September 23, 2014

ADDENDUM NO. 1

Notice to All Persons and Firms Proposing
to Submit a Bid or Furnish Materials for
Reavis Barracks – Mackenzie Road Infrastructure
St. Louis County Project No. AR-1413
Federal Project No. STP-4901(632)

SHEET SEQUENCE:
4A OF 53

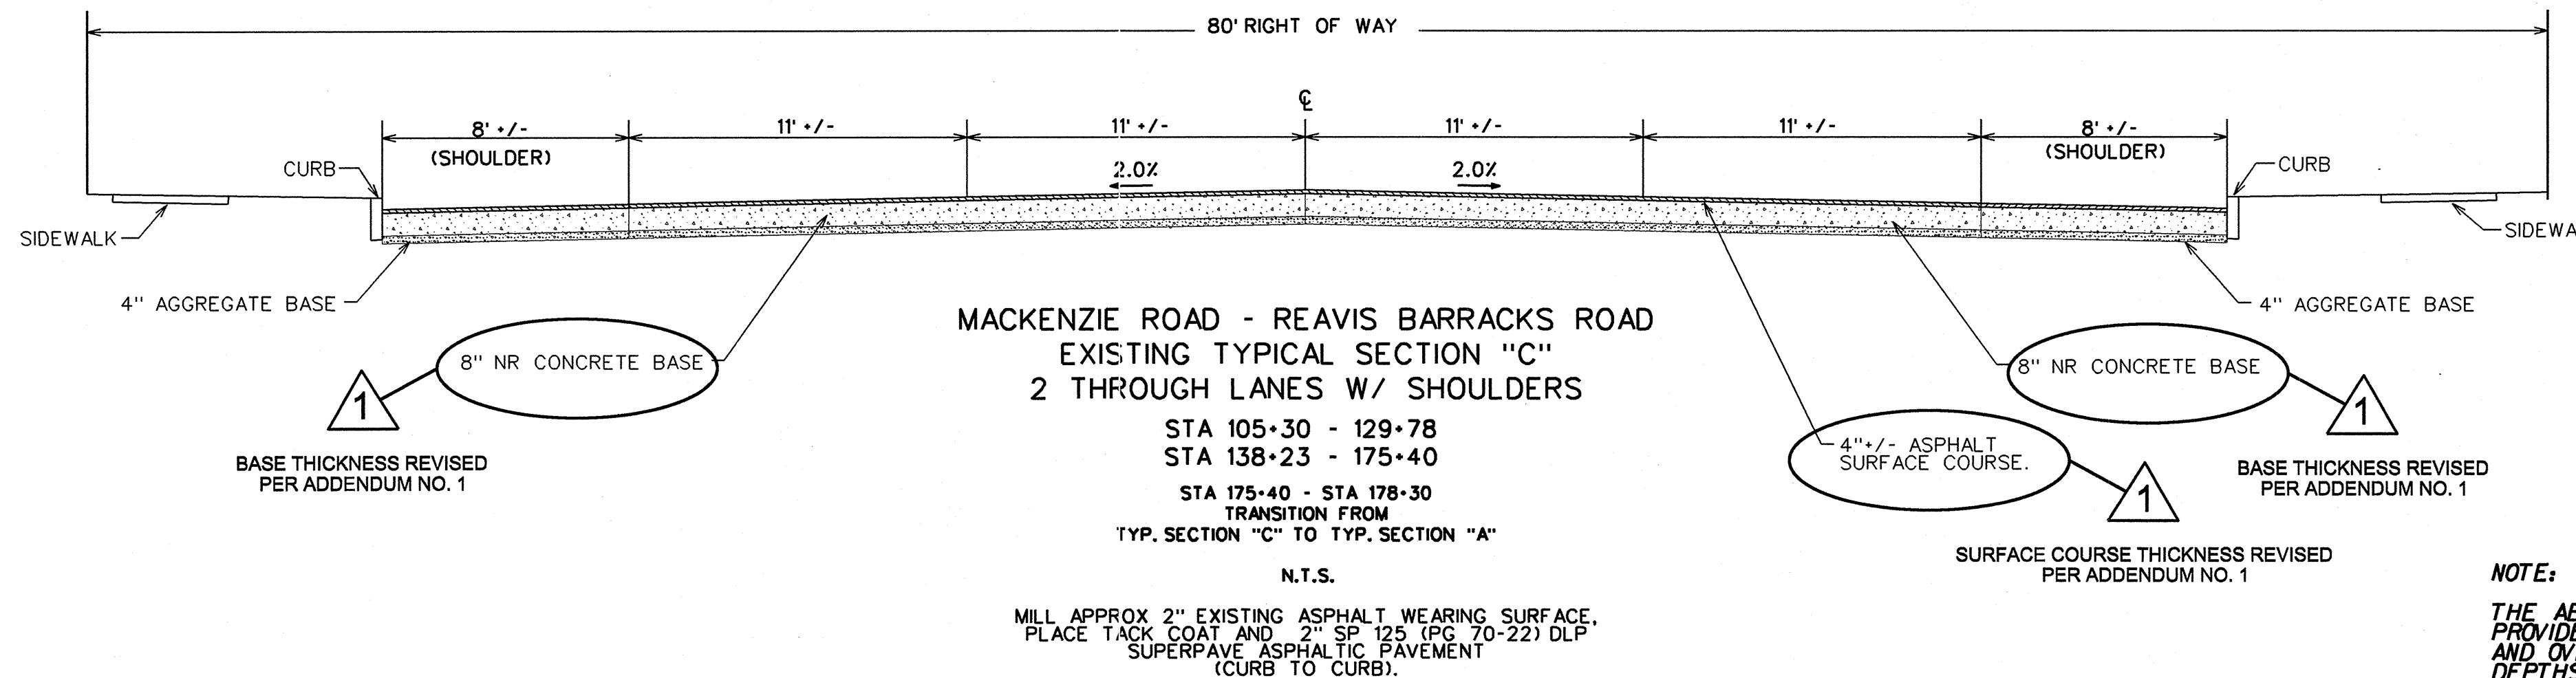
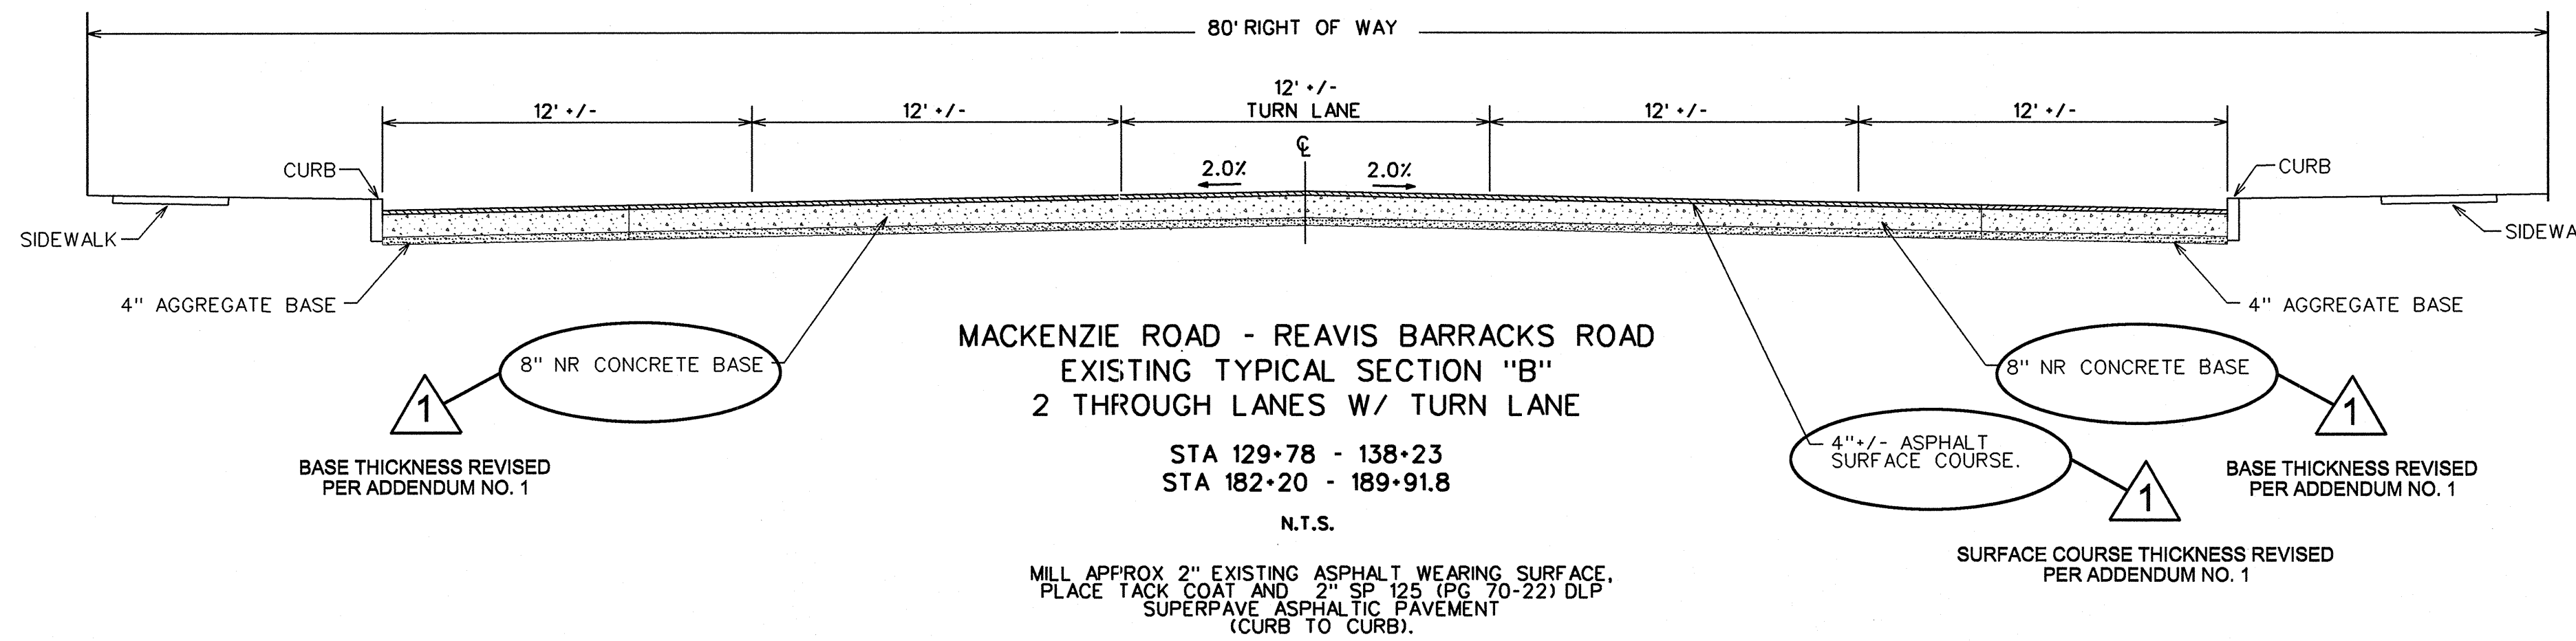
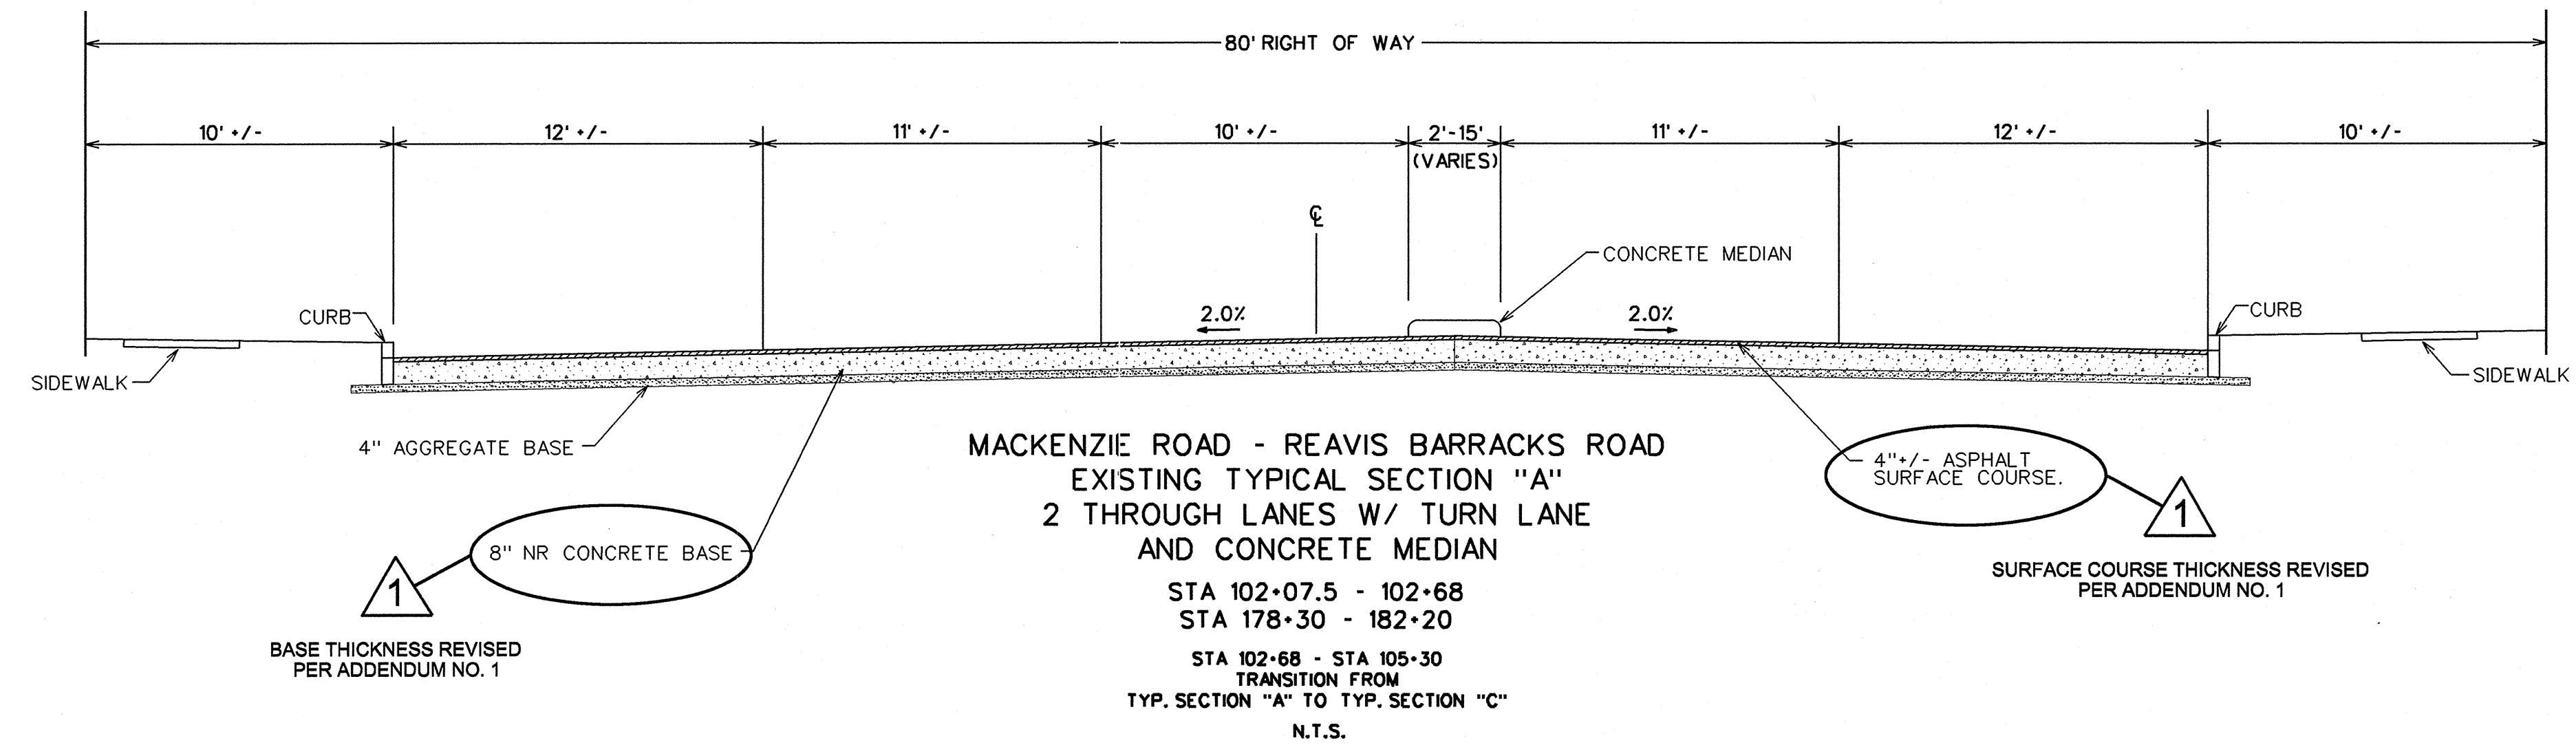
* INDICATES CHANGE IN QUANTITY UNDER ADDENDUM NO. 1
** INDICATES PAY ITEMS ADDED UNDER ADDENDUM NO. 1
ITEM NOS. 509-10.30, 509-10.40 AND 509-11.20 REPLACE ITEM NOS. 502-11.08, 509-10.08, AND 509-10.18.

509-10.30	CONCRETE BASE (VARIABLE THICKNESS, NON-REINFORCED), VERY EARLY STRENGTH **			
	As directed by the Engineer.			
	LOCATION	SIDE (Rt / Lt)	DIMENSIONS (L x W)	QUANTITY S.Y. (1.0)
	9700 Sterling Pl (Citizen's National Bank)	Rt	26' x 26'	75.1
	9700 Sterling Pl (Citizen's National Bank)	Rt	21' x 27'	63.0
	9700 Sterling Pl (Citizen's National Bank)	Rt	10' x 27'	30.0
	Mackenzie at Sterling Place	Rt	22' x 137'	334.9
	Mackenzie at Reavis Rd	Rt	45' x 12'	60.0
	Reavis Road	Rt	24' x 27'	72.0
	9765 Mackenzie (Phillips 66)	Rt	33' x 12'	44.0
	10001 Shapfield Ln	Rt	50' x 25'	138.9
	4834 Reavis Barracks	Rt	30' x 33.5'	111.7
	4824 Reavis Barracks	Rt	38' x 23'	97.1
	Reavis Barracks at Villa Ridge Ct	Lt	37' x 22'	90.4
	Reavis Barracks at Villa Ridge Ct	Lt	50' x 22'	122.2
	Reavis Barracks at Villa Ridge Ct	Lt	41' x 12'	54.7
	Reavis Barracks at Villa Ridge Ct	Lt	275' x 22'	672.2
	Huntingdon Lane	Lt	20' x 52.5'	116.7
	Huntingdon Lane	Lt	35' x 12.5'	48.6

509-10.40	CONCRETE BASE (VARIABLE THICKNESS, NON-REINFORCED), HIGH EARLY STRENGTH **			
	As directed by the Engineer.			
	LOCATION	SIDE (Rt / Lt)	DIMENSIONS (L x W)	QUANTITY S.Y. (1.0)
	Mackenzie at Irene Place	Rt	28' x 22'	68.4
	9347 Mackenzie	Rt	10' x 11'	12.2
	9425 Mackenzie	Rt	12' x 22'	29.3
	9441 Mackenzie	Rt	8.5' x 10'	9.4
	9801 Mackenzie	Rt	8.5' x 15'	14.2
	4812 Reavis Barracks	Rt	35' x 9'	35.0
	Reavis Barracks at Ummelmann	Rt	22' x 30'	73.3
	4700 Reavis Barracks	Rt	23' x 10'	25.6
	9926 Mackenzie	Lt	8.5' x 27'	25.5
	9918 Mackenzie	Lt	29' x 22'	70.9
	9890 Mackenzie	Lt	14' x 11'	17.1
	9764 Mackenzie	Lt	17.5' x 11'	21.4
	9548 Mackenzie	Lt	72' x 11'	88.0
	9522 Mackenzie	Lt	36' x 11'	44.0
	9406 Mackenzie	Lt	14' x 11'	17.1
	9321 Mackenzie	Lt	8' x 11'	9.8
	9122 Mackenzie	Lt	22' x 25'	61.1
	TOTAL			622.4

509-11.20	CONCRETE BASE (VARIABLE THICKNESS, NON-REINFORCED) **			
	Exact locations & quantities to be determined by the Engineer.			
	LOCATION	SIDE (Rt / Lt)	QUANTITY S.Y. (1.0)	REMARKS
	E.O.M. at I-55	Lt	450' x 22'	1,100.0
	Southridge Apartment Building	Lt	130' x 12'	173.3
	Southridge Apartment Building	Lt	32' x 12'	42.7
	Southridge Apartment Building	Lt	88' x 12'	117.3
	Southridge Apartment Building	Lt	110' x 12'	146.7
	TOTAL		1,580.0
